PRE-APPLICATION CONFERENCE
NW 9th Ave Subdivision & Rezone (2025-013-PAC)

Site Address	33901 NW PACIFIC HWY
Legal Description	#58 SEC 34 T5N R1EWM 4.76A & 33 SEC 34 T5N R1EWM
Applicant	Danny Wisner/ Danny Martin (360) 949-5607 dan@songbirdhomes.com 10013 NE Hazel Dell Ave. PMB 504, Vancouver, WA 98685
Owner	RAR Trust FBO Daniel Wisner 3521830 etal (360) 949-5607 wisnerdan@gmail.com 33901 NW Pacific Hwy La Center, WA 98629
Applicant's Representative	Travis Johnson PLS Engineering (360) 944-6519 pm@plsengineering.com 604 W Evergreen BLVD Vancouver, WA 98660
Proposal	The applicant is requesting to rezone approximately 11.3 acres (parcels 258902000 & 258921000) from LDR-7.5 to MDR-16 and subdivide the property into 82 single-family attached and detached lots.
Date of Conference	April 16, 2025

COMMENTS TO 9TH AVENUE SUBDIVISION

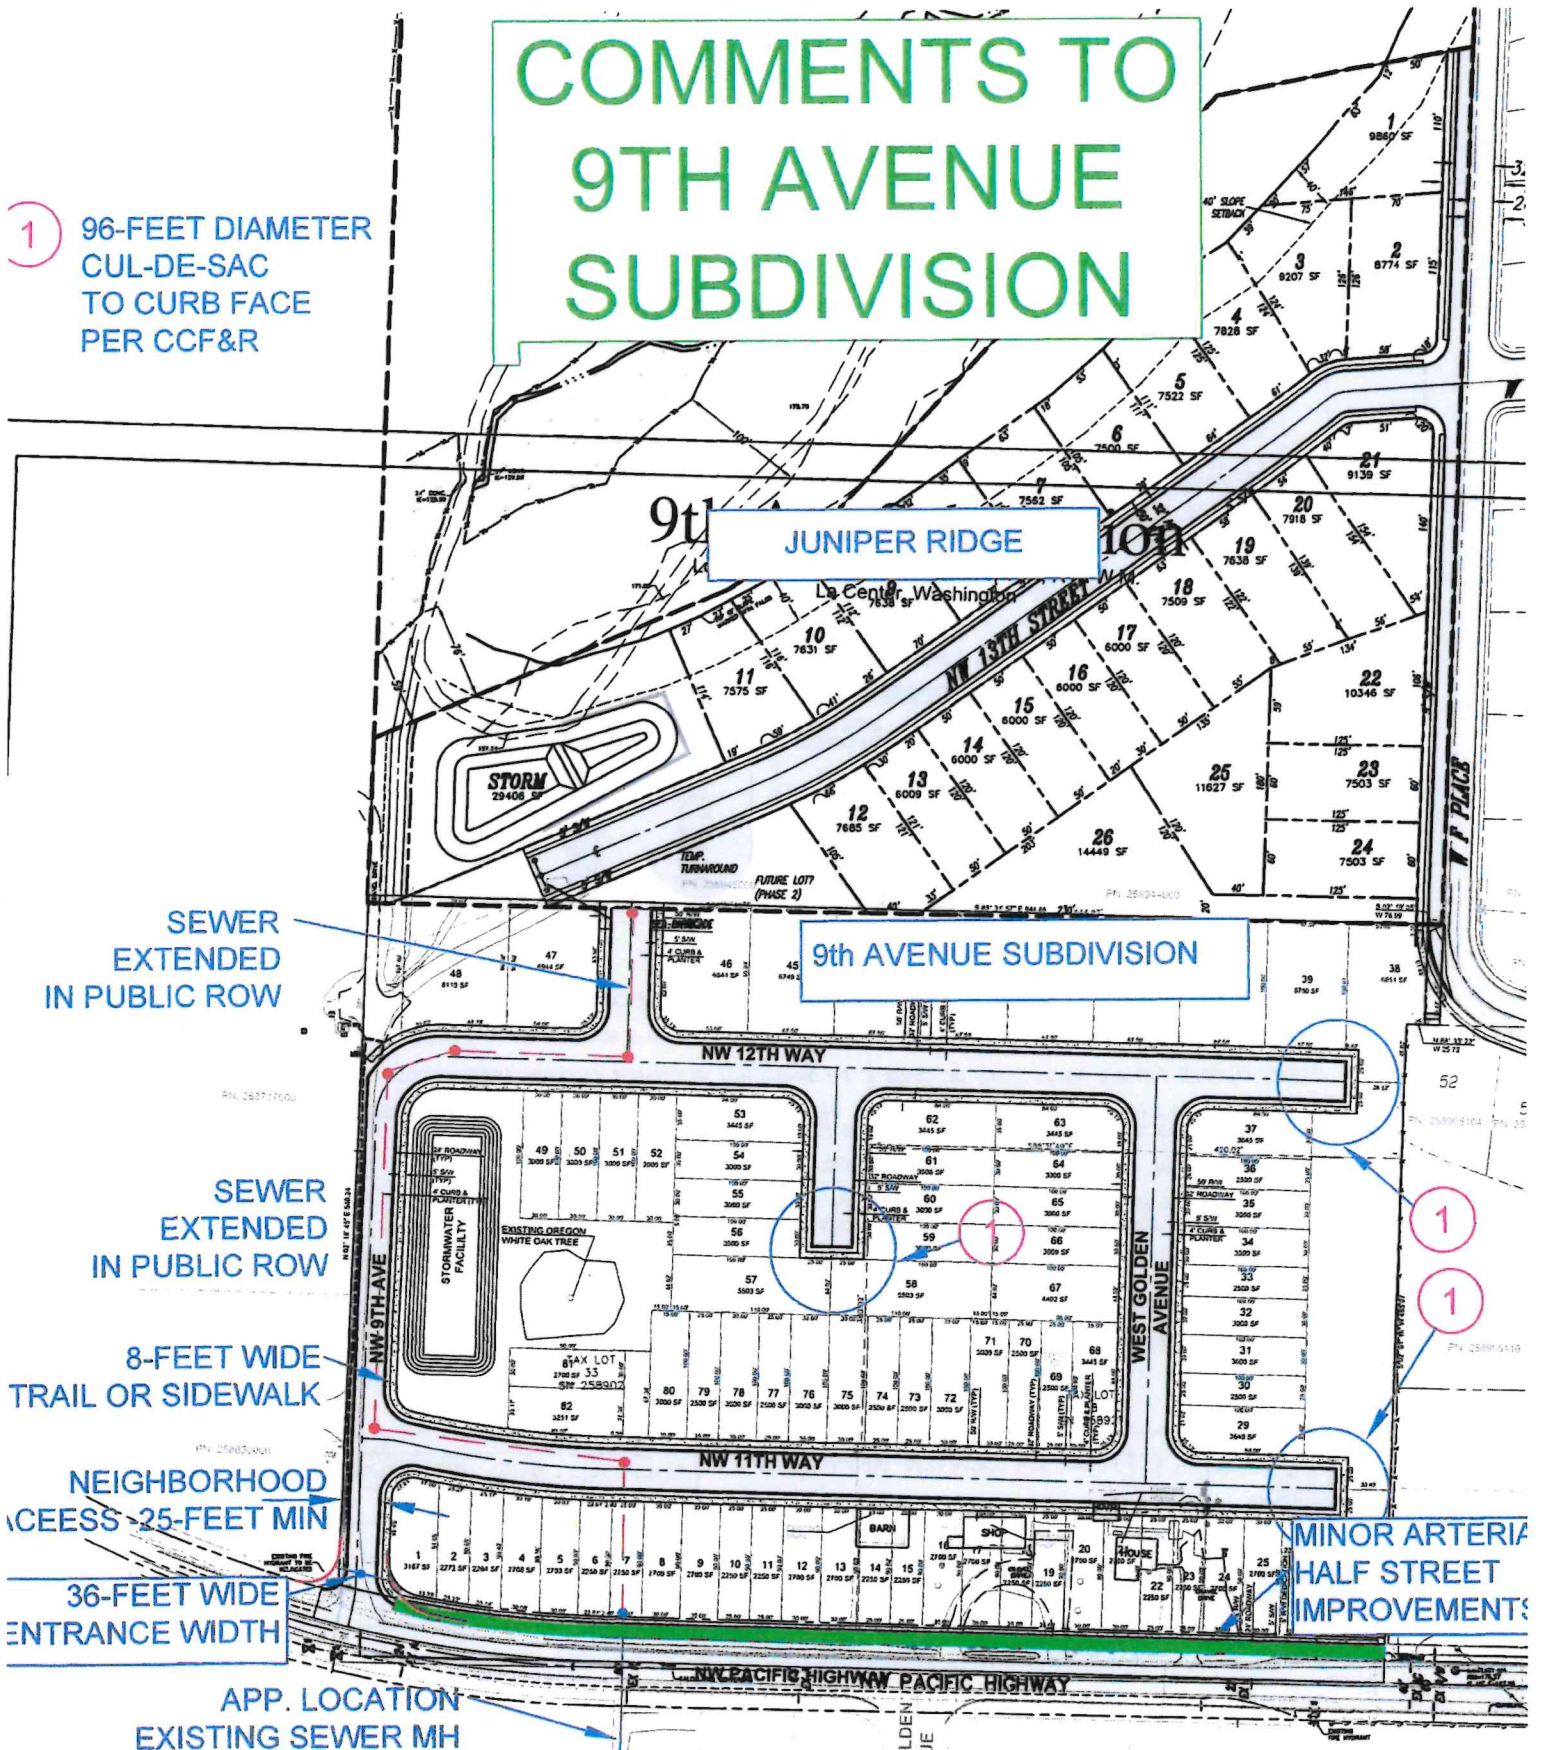
① 96-FOOT DIAMETER
CUL-DE-SAC
TO CURB FACE
PER CCF&R

SEWER
EXTENDED
IN PUBLIC ROW

SEWER
EXTENDED
IN PUBLIC ROW

8-FOOT WIDE
TRAIL OR SIDEWALK

NEIGHBORHOOD
ACCESS - 25-FEET MIN

36-FOOT WIDE
ENTRANCE WIDTH

APP. LOCATION
EXISTING SEWER MH

MINOR ARTERIAL
HALF STREET
IMPROVEMENTS
